**HARBOUR VIEW STATION WEST
 MIXED USE DEVELOPMENT
 OVERLAY DISTRICT
 A - PHASE 2**

HARBOUR VIEW STATION WEST
 MIXED USE DEVELOPMENT
 OVERLAY DISTRICT
 PREPARED FOR
 HVS WEST, LLC

2ND CITY SUBMITTAL	09/05/2014	BSS
3RD CITY SUBMITTAL	09/26/2014	BSS
2 BID ADDENDUM - STORM INVERTS	10/08/2014	BSS
4TH CITY SUBMITTAL	10/28/2014	BSS
1 VALUE ENGINEERING REVISIONS	11/26/14	BSS
No.		
REVISIONS	DATE	BY

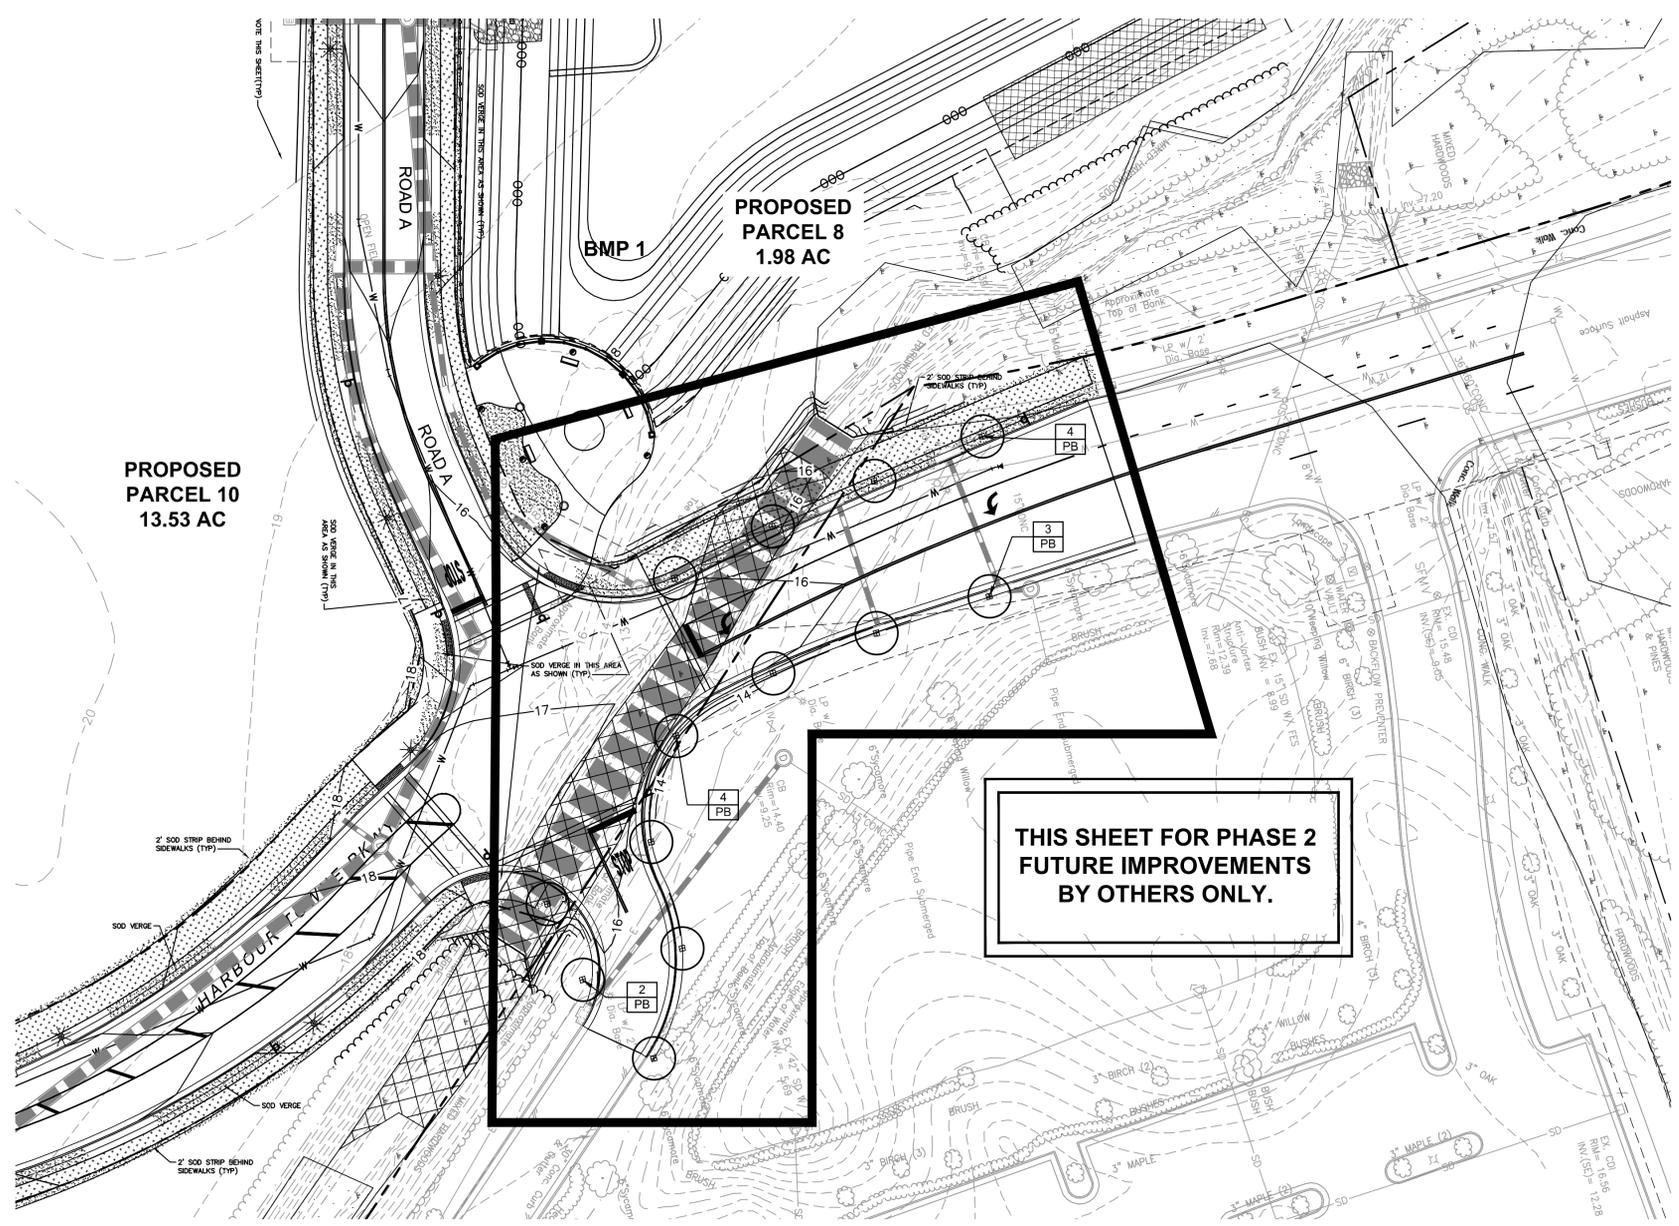
LANDSCAPE REVISED TO ADD OPEN SPACE PLANTINGS, REMOVE SHRUBS FROM VERGE AND ADD ACCENT PLANTINGS.
